Report: TAB REPORT
Function: Test, Adjust, & Balance
Date: 10/07/2025
Completed By: National TAB

PROJECT
09-29-25 QT #0541 DES MOINES, IA

Project: 09-29-25 QT #0541 DES MOINES, IA

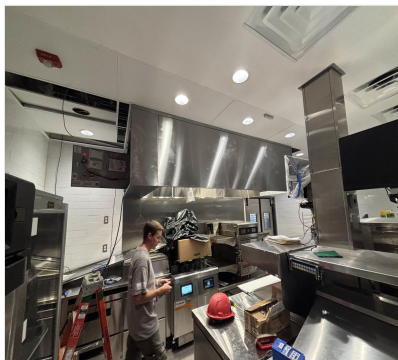
End panels are installed per prototype? Fail

End Panels were not installed at the time of TAB.
